## Dear Historic Preservation Commission:

We are writing to file an objection to the proposed COA for (an already built) permanent brick structure at 3316 N Lake Drive.

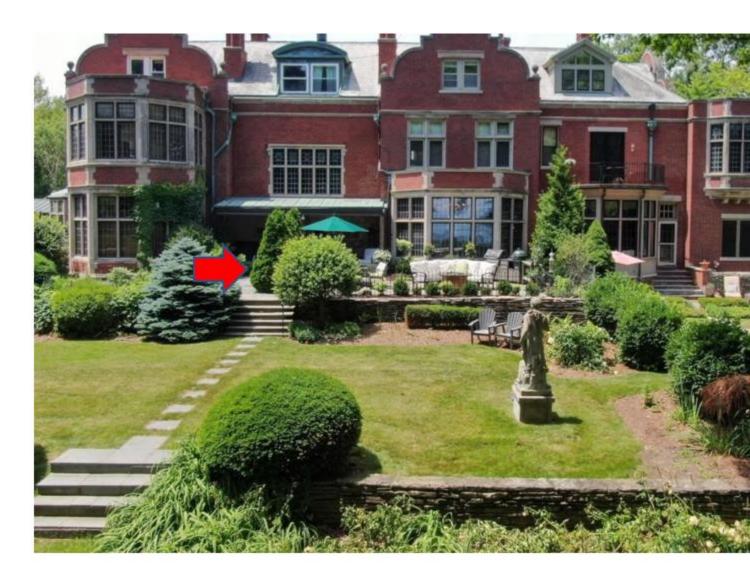
Milwaukee architects Charles Kirchhoff and Leslie Rose designed the Joseph A. Uihlein House at 3318 N. Lake Drive in 1907; the home was enlarged in 1914 and 1917. The style is Jacobean. The house was subdivided into condominiums in 1985. Raised bed planters- brick or not- was not a feature of homes in this era nor of this architectural style. These structures are not found at any Kirchhoff and Rose designed homes including the Herman Uihlein House at 5270 N Lake Drive, nor are they a permanent adjoining feature of any other buildings designed by these architects. Raised beds did not gain popularity until the early 1970's, making this permanent masonry structure historically inconsistent with the building and architects' vision. Although this masonry structure is not touching the foundation it is immediately adjacent to/only 1-2 feet from the building and looking at the east elevation from ground level this is indistinguishable (see photo).

This permanent brick structure is feet from the east window of the adjoining unit and prominently seen looking out the window sitting in that neighboring unit's living room. The 3316 unit is currently on the market; it has been unoccupied and on sale since October 15 which mitigates the stated justification for building this. The owner stated in filed documents with HPC that he "replaced overgrown dyeing (sic) trees blocking stairs and walkways"- this is

Before construction photo:

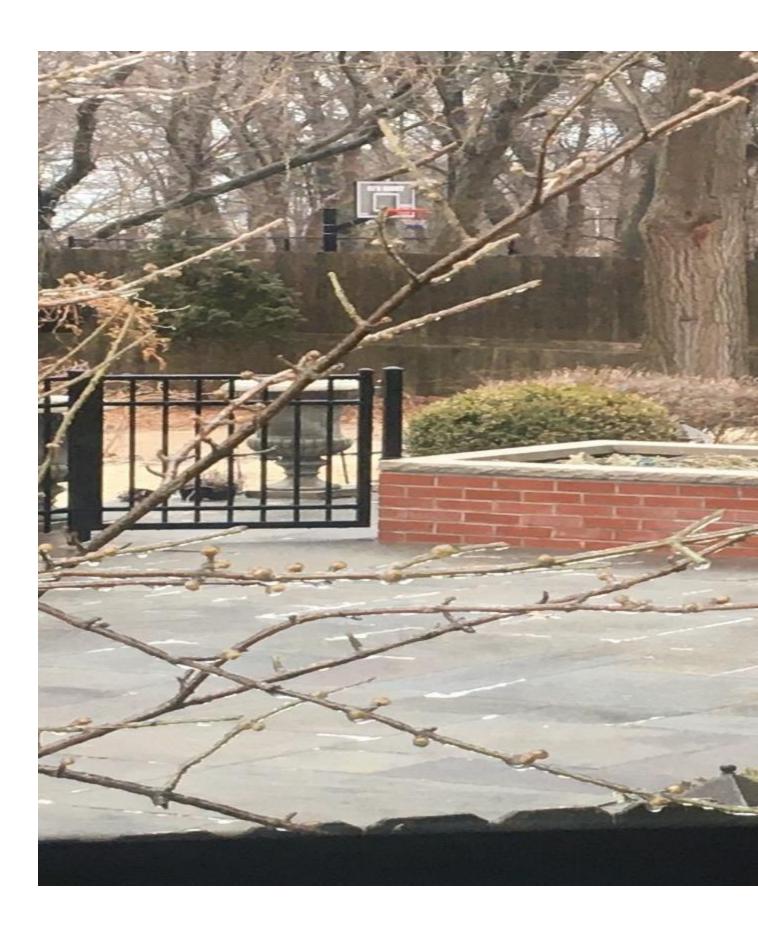
As one can see the shrubs were not any closer to the stairs than the new brick structure is to the stairs; the remedy for overgrown shrubs is trimming them back or removing them and replacing, not building a historically inaccurate new permanent brick structure.
